Work Order ID 101373

Item Name: Crosstube Turning Detail

DART AEROSPACE LTD	Work Order: 101373
Description: Crosstube Assembly (205/212/412 High Fwd)	Part Number: D212-664-141
Inspection Dwg: D212-664-141 Rev: D	Page 1 of 2

DRAWING NO. D212-664-141	TITLE XTUBE ASSY (205/212/412 HI FWD)	REV. D	DART AEROSPACE LTD ENGINEERING ORDER		D.E.O. NO. D212-664-141-D-1	SHEET NO. SHEET 1 OF 2	SCALE NTS
DRAWN	CHECKED <i>OP</i>	MFG. APPR. <i>ER</i>	APPROVED <i>MP</i>	DE APPR. <i>HH</i>			
DATE 11.04.07	DATE 11.04.11	DATE 11.04.12	DATE 11/04/12	DATE 11.04.12

**D212-664-141/-141B
ASSEMBLY DETAIL**

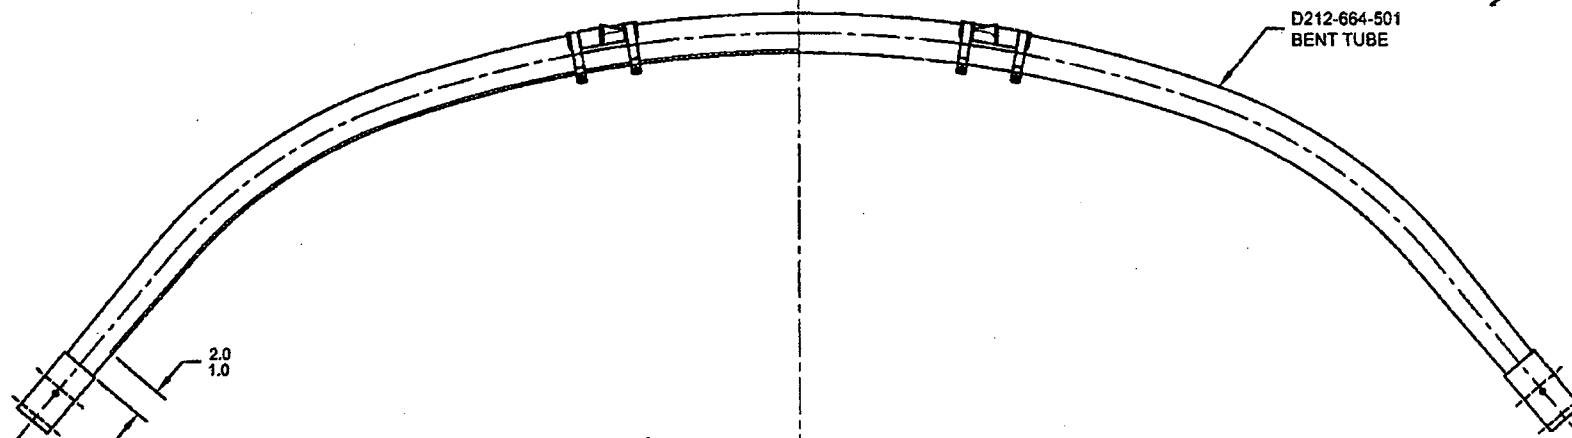
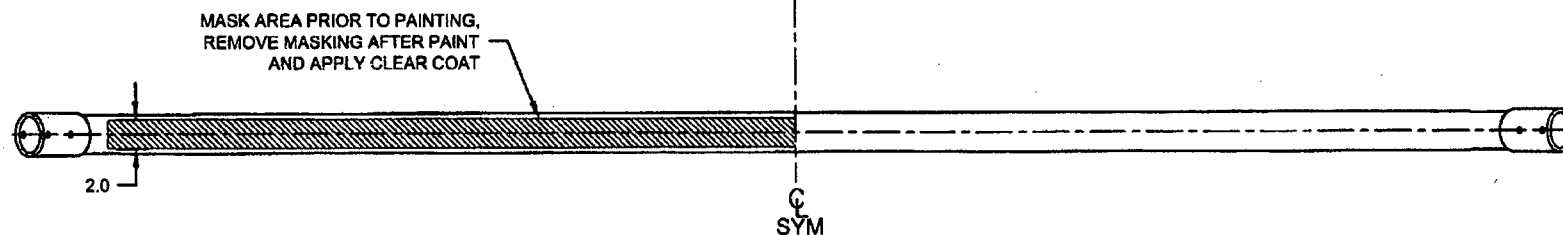
PURPOSE:

ADD AN INSPECTION WINDOW TO UNDERSIDE OF CROSSTUBE.

NOTES 2 OF SHEET 1 IS AMENDED AS FOLLOWS:

- 2) FINISH: CHEMICAL CONVERSION COAT PER DART QSI 005 4.1
PRIME INSIDE AND OUTSIDE PER DART QSI 005 4.2
MASK UNDERSIDE OF CROSSTUBE AS SHOWN (HATCHED AREA) AND
PAINT OUTSIDE PER DART QSI 005 4.2
REMOVE MASKING AND APPLY CLEAR COAT
